Access Compliance Report

Public Rights-of-Way

(Curb Ramps)

Intersection ID: 13770	Main Street: HAWKINS_ST	Cross Street: W_KINGSTON_AV	Location: W
ADA ID: 878B9F02A2F8	Ramp Type: Perp	Initial Pass/Fail: Fail	Overall Compliance: No
		Severity Score: 60

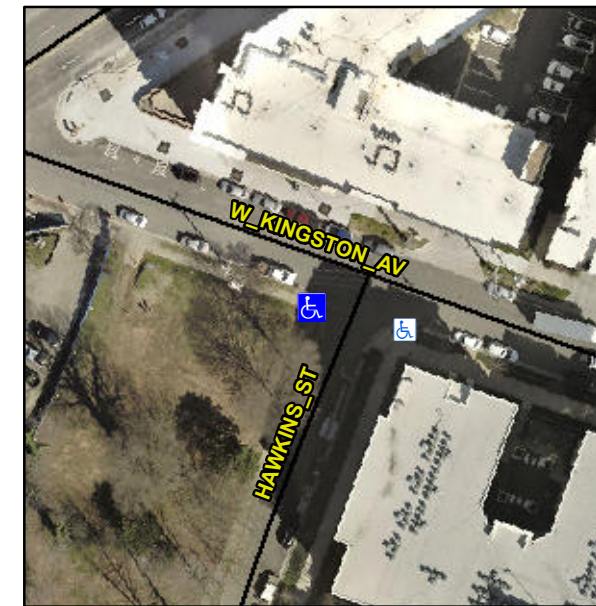
Not Found, R304.5.1, R304.5.3

Compliance	Description	Data	Compliance	Description	Data
N/A	Ramp Length (in)	75.0	Yes	Ramp Slope (%)	5.6
No	Ramp Width (in)	28.0	No	Ramp XSlope (%)	8.7
N/A	Flare Type LT	N/A	N/A	Flare Type RT	N/A
N/A	Flare Slope LT (%)	N/A	N/A	Flare Slope RT (%)	N/A
N/A	Flare Traversable LT?	N/A	N/A	Flare Traversable RT?	N/A
N/A	Landing Length (in)	N/A	N/A	DWS Provided?	N/A
N/A	Landing Width (in)	N/A	N/A	DWS Contrast?	N/A
N/A	Landing Slope (%)	N/A	N/A	DWS Length (in)	N/A
N/A	Landing X Slope (%)	N/A	N/A	DWS Full Width?	N/A
N/A	Landing Curb? (Y/N)	N/A	N/A	DWS Offset (in)	N/A
N/A	Shared Landing?	N/A			
N/A	Gutter Ponding?	N/A	N/A	Gutter Slope (%)	N/A
N/A	Gutter Lip Ht (in)	N/A	N/A	Gutter X Slope (%)	N/A
N/A	Painted X Walk1?	No	N/A	Painted X Walk2?	N/A
	X Walk 1 Direction	To SE		X Walk 2 Direction	N/A
N/A	X Walk 1 Width (in)	N/A	N/A	X Walk 2 Width (in)	N/A
	X Walk 1 Slope (%)	3.0		X Walk 2 Slope (%)	N/A
	X Walk 1 X Slope (%)	4.0		X Walk 2 X Slope (%)	N/A

Remove & Replace Entire Ramp.
